October 1, 2021

Re: App 21-36P – 25 Talbot Lane SP

This letter is written to address your review comments dated August 27, 2021. The accompanying plan set incorporates our responses to these comments. For ease of your review, your initial comment is in *italics*, followed by our response in **bold**.

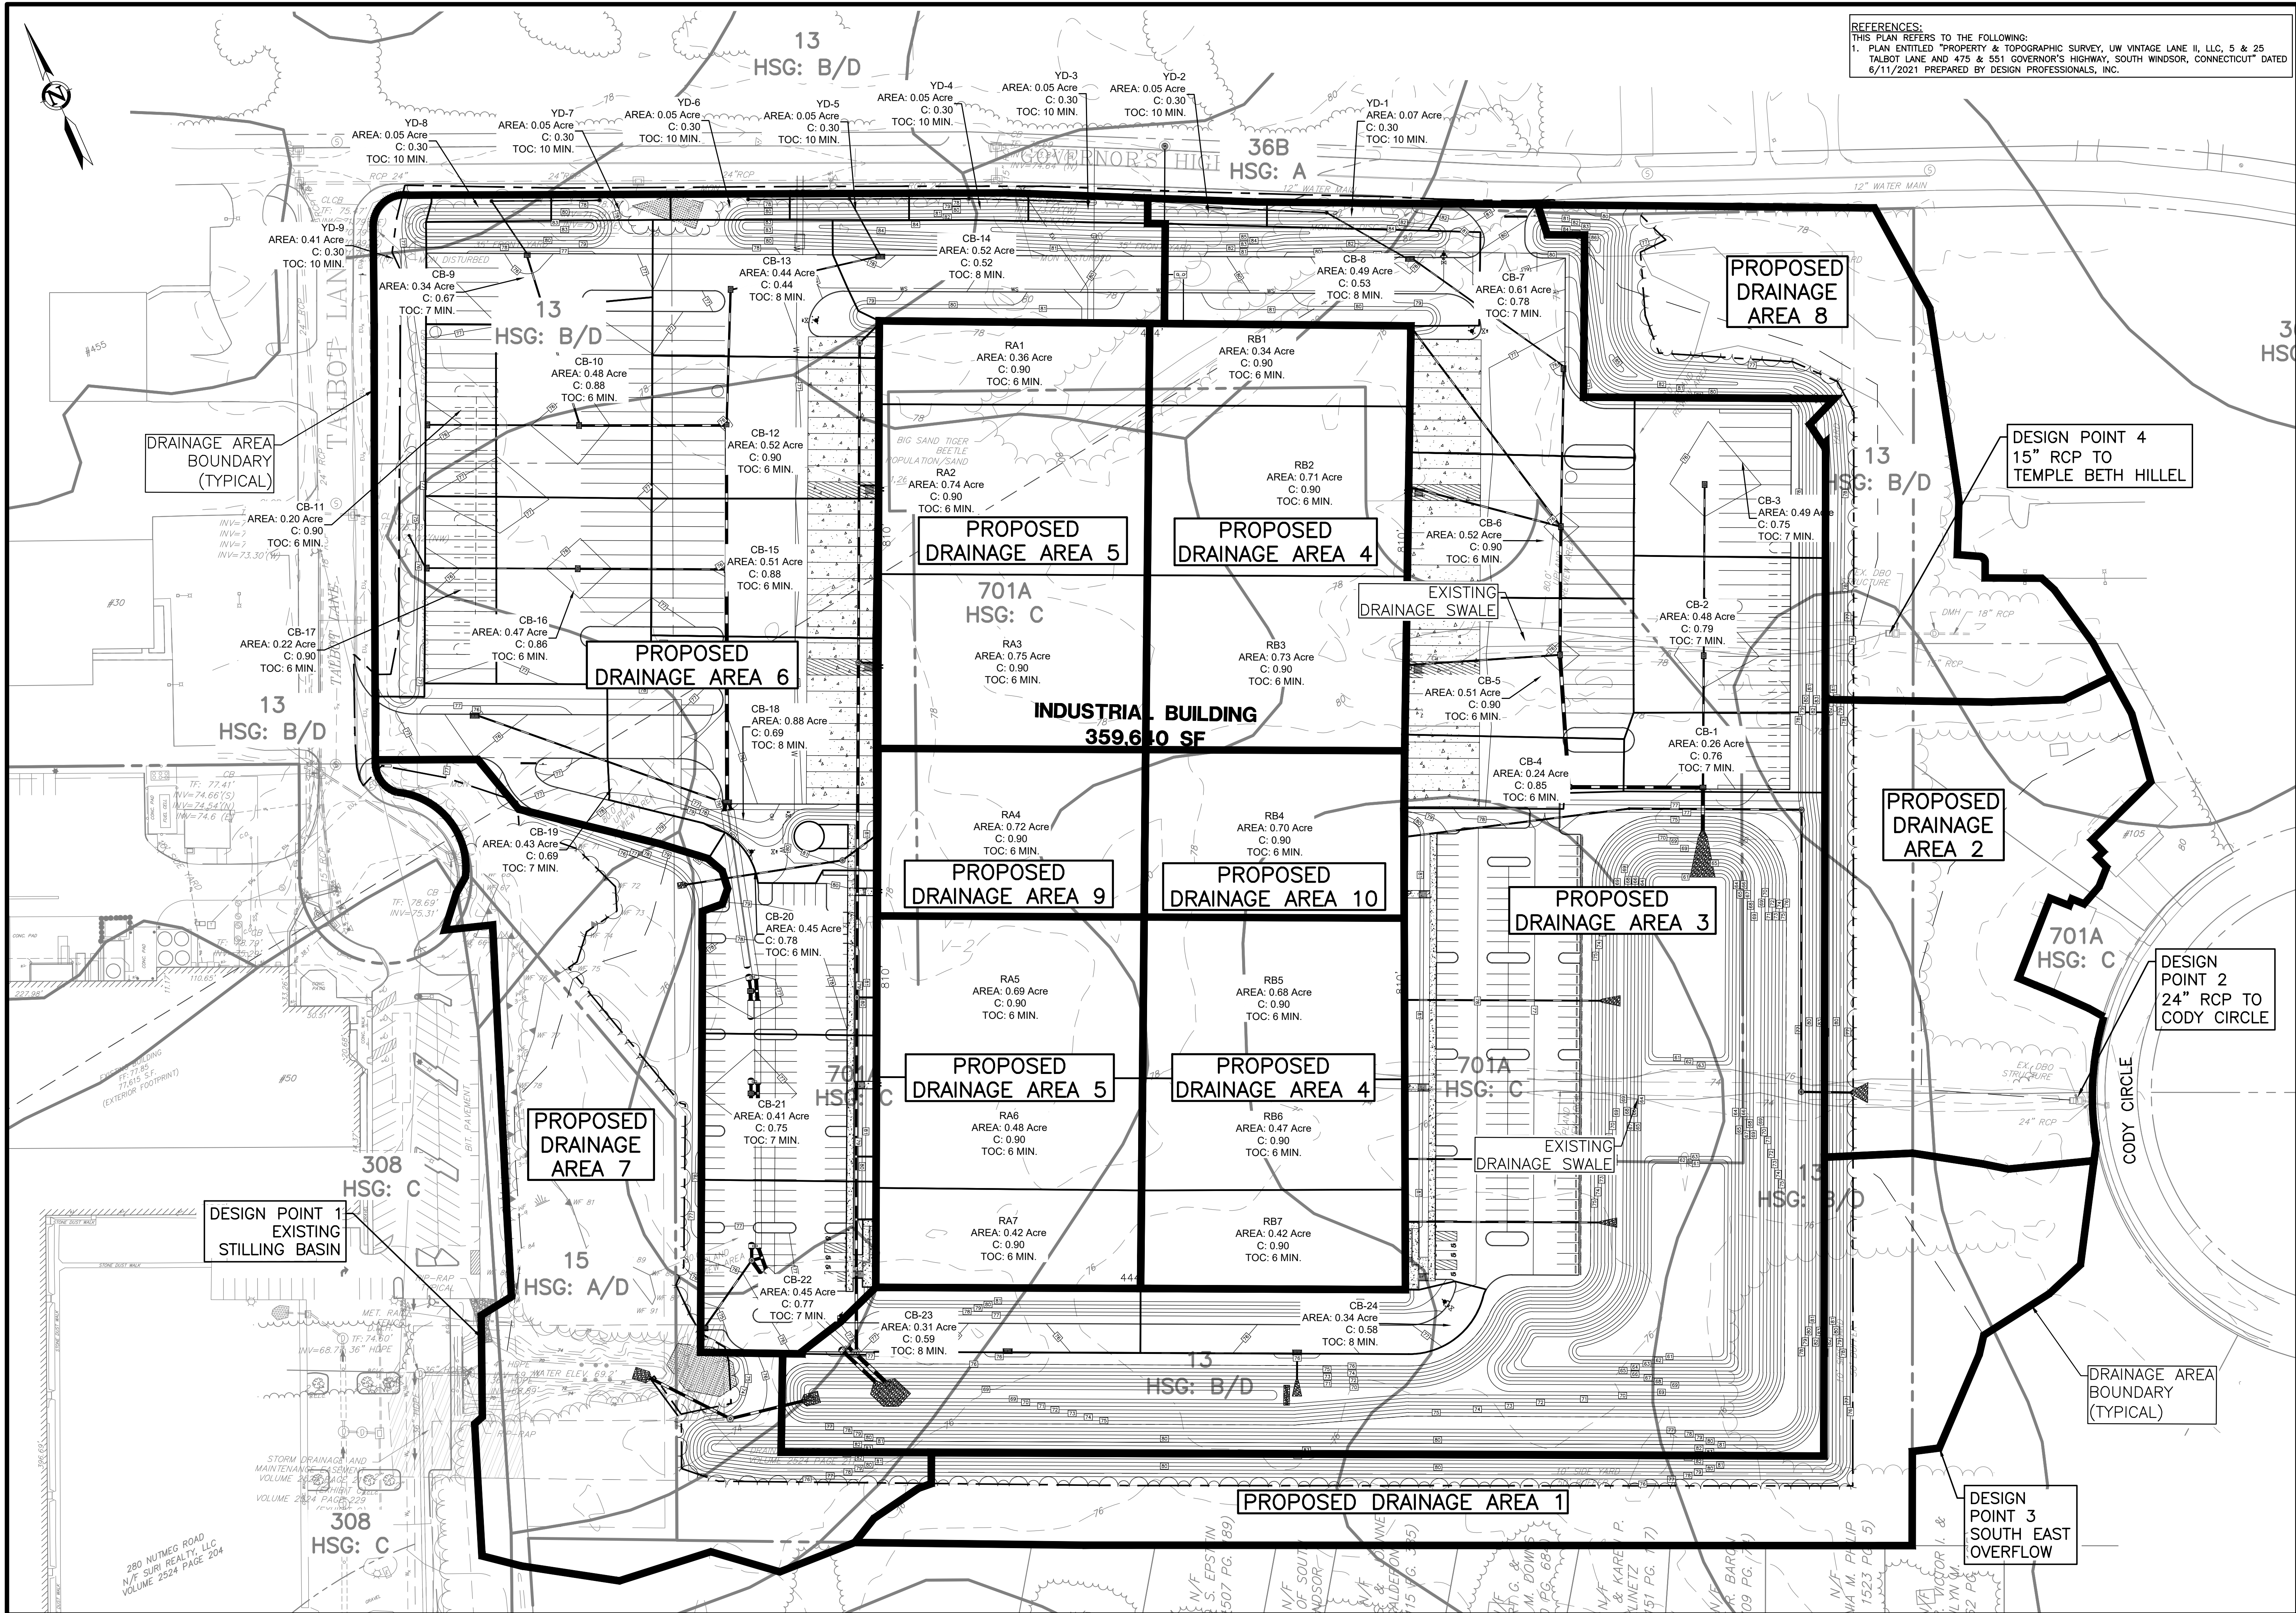
- b. *The Stormwater Report indicates the water level in the large detention basin will be elevation 72. 52 during a 10-year storm. This will result in water backing up in many storm drain pipes on site during most storms and possibly lead to siltation, clogging, freezing and other problems with the storm drain system such that it does not function as designed for the 10-year storm. All the storm drain pipe outlets into the detention basin (except for those from the underground infiltration system) should be raised about the projected 10-year storm elevation and other pipes in the storm drain system raised accordingly.*

The storm sewer analysis for the site was revised to consider pond tailwater conditions for the 10-yr storm. Pipes were upsized to prevent fully submerged conditions and provide greater than or equal to 1.5' of freeboard in catchbasins during a 10-yr storm event. The outlet from the water quality basin was also lowered to bring the 10-yr elevation to 72.13 to assist in relieving submerged pipe conditions. Revised Storm Sewer results are included as an attachment to this response. Updated pre and post condition analysis results to DP#1 based on changes to the pond outlet elevation are shown below:
